SUBJECT: ISSUANCE OF NUREG-1306, SOUTH TEXAS PROJECT, UNITS 1 AND 2

The U. S. Nuclear Regulatory Commission has issued NUREG-1306 entitled "NRC Safety Significance Assessment Team Report on allegations related to the South Texas Project, Units 1 and 2."

Figure 5.1-3 Feedwater Pipe and Rupture Restraint Structure
Attached to Reactor Coolant Pipe Rupture
Restraint (RC1125R1)

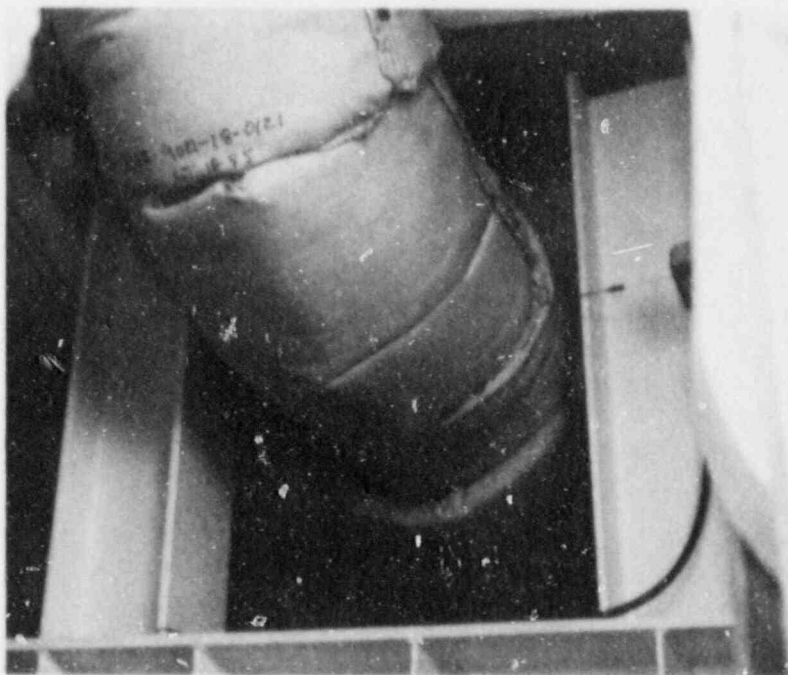
The SSAT reviewed the reactor coolant pipe whip restraint design drawing RC-1125-R1 and all associated design documentation for the large-bore pipe supports that have remained attached to the pipe whip restraint structure. The large-bore pipe support design drawings reviewed were FW-9012-HLS011, Revision 1, and RC-9125-HL5007, Revision 4. The SSAT performed a field walkdown to assure that the subject supports were the only two large-bore attachments to the pipe whip restraint. The SSAT also inspected, in a limited way, the as-built configuration of the large-bore supports to verify items such as utilization of correct material, support location and orientation, load settings, heat numbers, and material traceability (see Figures 5.1-2 and 5.1-3). Each of these areas was found to be acceptable. In addition, this information coincided fully with the documentation provided in the applicable N-5 code data reports reviewed by the SSAT.

While reviewing the design drawing for the pipe whip restraint, the SSAT noted note 7 which stated that: Based on the revised analyses, the pipe whip restraints defined on the drawing were not required; the pipe whip restraint support structures that are already erected may be left in place, provided that the constructor document completion of the structural erection and successful acceptance inspection of the completed work through established procedures; and structures that are partially erected or questionable because of uncertain completion, or not documented as completed and inspected, shall be removed.

However, the SSAT also noted a revision to the drawing that added note 5 which stated that no additional attachments are to be made to this (pipe whip) restraint. The SSAT informed HL&P that this note could be misinterpreted by other engineering disciplines and should be removed or revised to restrict attachments unless approved by civil/structural engineering personnel. Before the end of the inspection, the Civil/Structural Department reviewed all design drawings for Units 1 and 2. No other notes of this type were found, and the above note was corrected; this was verified by the SSAT.

The SSAT determined that this allegation was not substantiated. The design documentation that was developed to remove the structure as a pipe whip restraint was adequate as well as the design documents and code data reports for the attached feedwater pipe supports.

Figure 5.5-1 Weldments Showing Typical Bead Characteristics of E7018 and E6011 Weld Rods

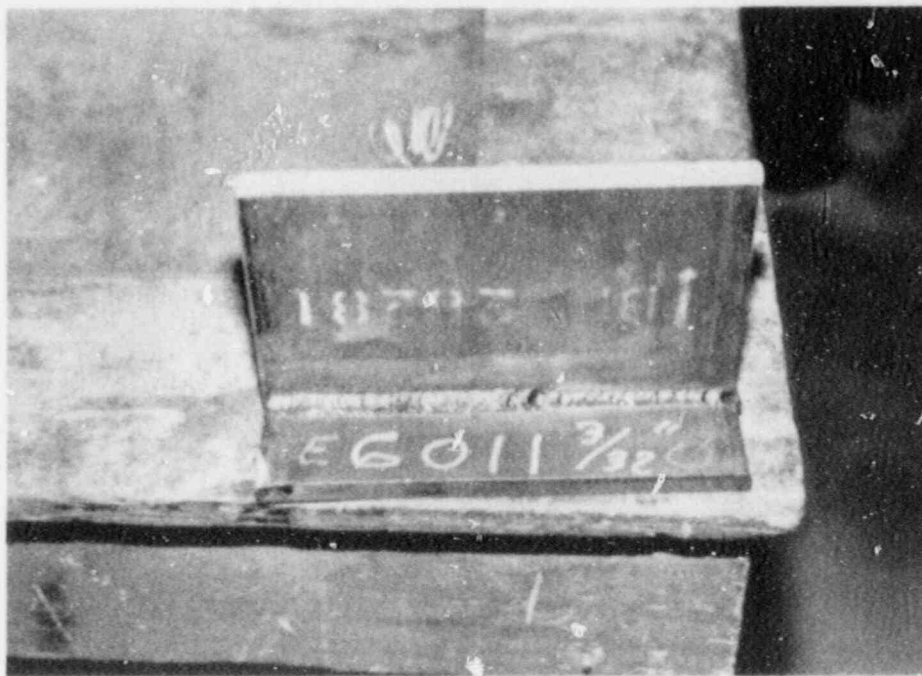
In an effort to determine whether the E7018 electrodes in the unacceptable lot had been used in place of E6010 or E6011 electrodes for HVAC welding, the SSAT requested Ebasco to prepare weldments of the same material used in the HVAC system with two different type electrodes, E6011 and E7018. This was done to ascertain the typical bead characteristics of each electrode to aid in the HVAC weld inspections. The welds made with the E7018 electrode show a smoother surface profile than welds made with the E6011 rod (see Figure 5.5-1(a) and (b)).

The SSAT conducted an extensive visual inspection of numerous welds on ducts and supports in the HVAC system in the MEAB, RCB, DGB, FHB, and the space above the control room. Although most of the welds had been painted, thereby making it difficult to fully interpret each of the weldment characteristics, the visual inspections performed on the welds were sufficient to allow the SSAT to determine whether the welds were of good quality and appeared to meet design specifications and AWS Code requirements. In addition, 14 HVAC system support construction packages were reviewed by the SSAT for dates of final signoff and completeness and compared to the filler material issue record (FMIR) dates. Also, the SSAT reviewed the certifications of the welders who performed the welds on these supports. The SSAT determined that the documents were in order, the correct welding electrodes were issued, and the welders were qualified to weld to both applicable welding procedures, WP-167 and WP-5. The SSAT also determined that these weldments had been inspected and accepted by the QC organization.

Figure 5.6-1 Raychem Splices

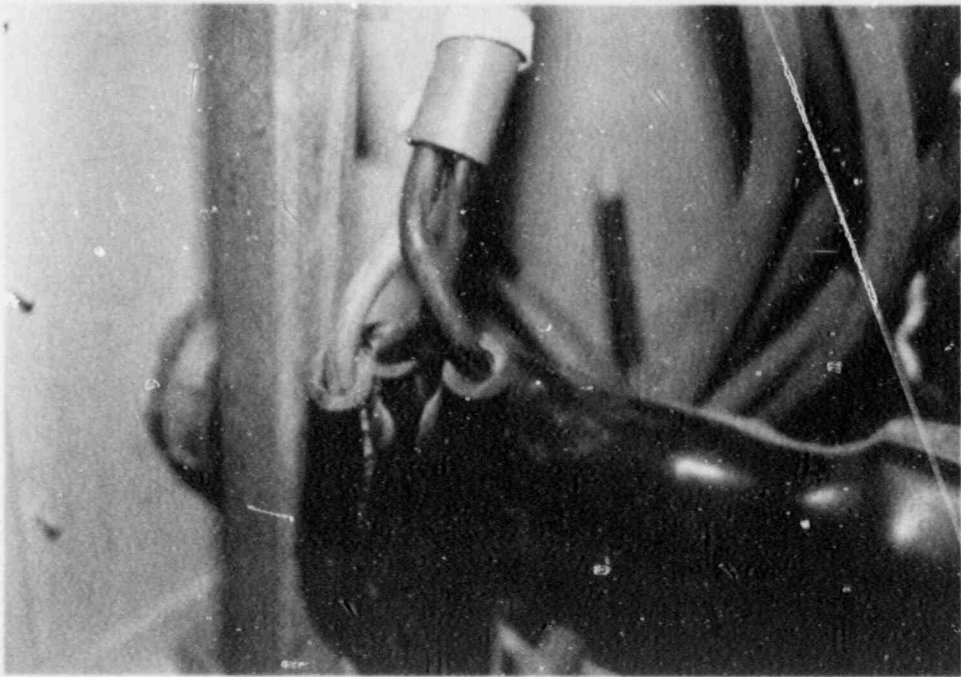
The SSAT also examined the splices on the inboard and outboard sides of electrical penetration EPA-17 on STP Unit 1 (see Figure 5.6-1(a) and (b)). Additionally, two terminal boxes in the Unit 1 reactor containment building were opened and the SSAT inspected the Raychem splices. The SSAT observed the following items and found them to be acceptable:

Pursuant to 10 CFR Part 50.55e, HL&P notified the NRC on March 1, 1988 that six Raychem cable splices were installed incorrectly. Two members of the SSAT visited the STP facility between March 4 and March 8, 1988, to review the significance of these findings, determine the root cause, and assess the generic implications.

The SSAT determined that 91 (of approximately 2300) Raychem splices were identified as having been excluded from earlier reinspections performed by HL&P. As a result of a reinspection of the 91 splices, 3 were identified as needing rework and another 3 splices were identified as marginal. The SSAT determined that all 6 splices had been reworked by HL&P.

Figure 5.8-2 Area Under Lamp Maintenance Access on Polar Crane Catwalk With Taped Areas Not Coated

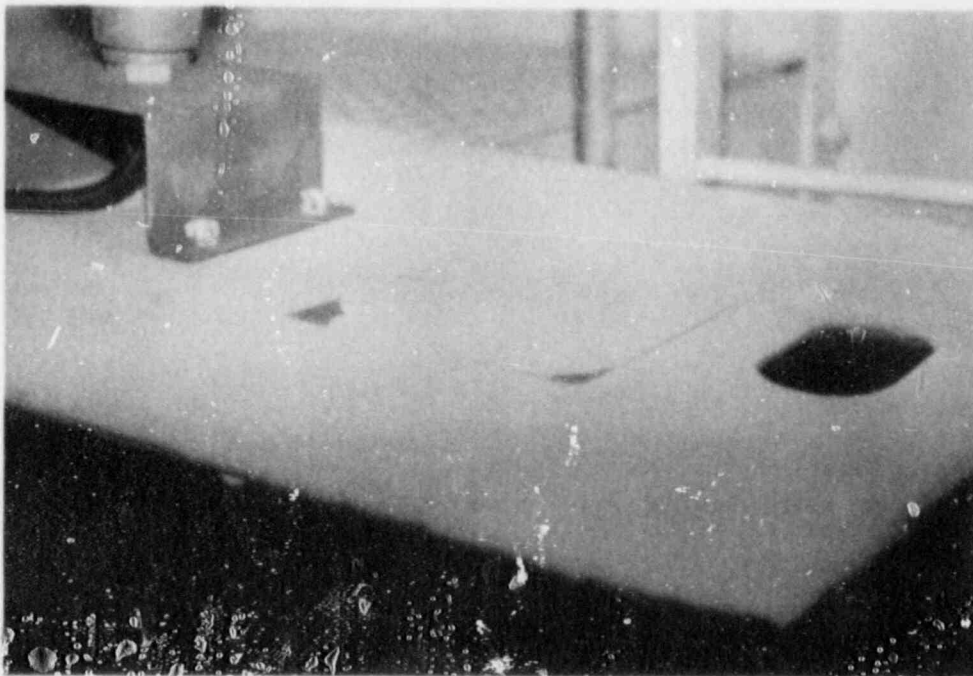
One small (9-inch x 12-inch) area under a lamp maintenance/access plate on the polar crane catwalk was found by the SSAT to be improperly coated (see Figure 5.8-2). The area had been taped before application of the topcoat, possibly as the attachment point for the lamp. However, when the lamp was attached in another location, the tape was not removed and the area was not topcoated. There were also several small areas under the girders above the trucks for the crane where the topcoat had not been applied. It appears that the girder had been resting on blocks in this area when the topcoat had been applied. The SSAT determined that the proper thickness of inorganic zinc primer was found in these areas.

Figure 5.10-1 Lower Portion of Orbital Bridge
(As Seen From the Polar Crane Catwalk)

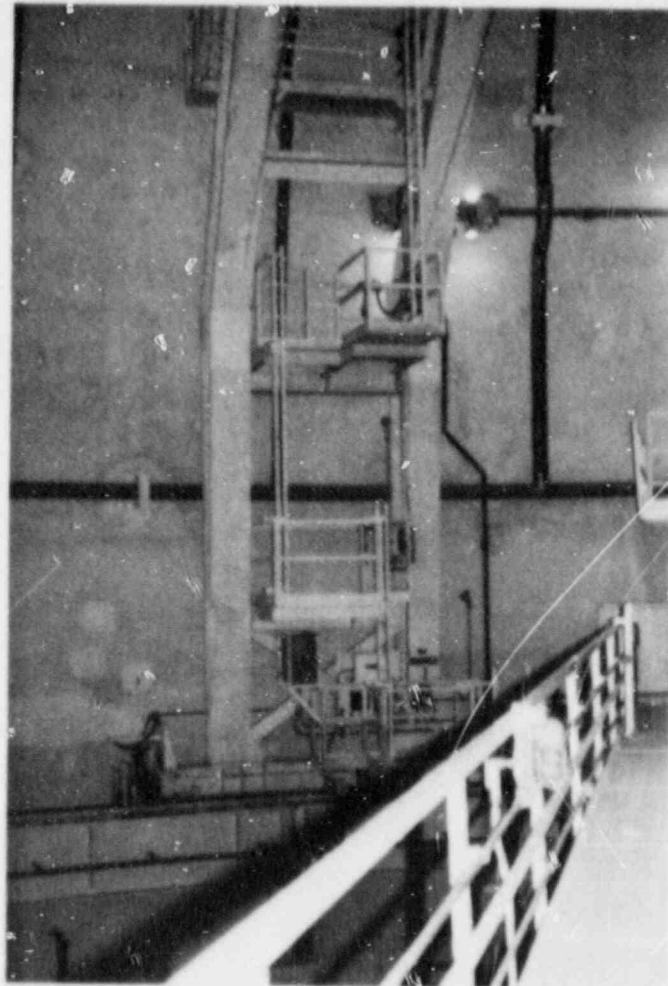
The orbital bridge is non-safety-related, seismically qualified, and self-propelled and is used as an inspection platform. Its base rides on the same track as the polar crane. The orbital bridge is used for inspecting and servicing the containment spray pipes that are attached to the containment dome (see Figure 5.10-1).

The SSAT inspected the polar crane and orbital bridge, reviewed crane and bridge drawings, field change requests (FCRs), nonconformance reports (NCRs), deficiency reports, nondestructive examination reports, quality control inspection reports, and crane operator inspection reports. The SSAT also conducted interviews with STP site personnel who were involved with the assembly, maintenance, and inspection of the polar crane and orbital bridge. Based on the reviews, interviews and field examinations of germane documentation and hardware, the SSAT determined that at one time during construction of Unit 1, the polar crane and orbital bridge did not have the manufacturer-supplied
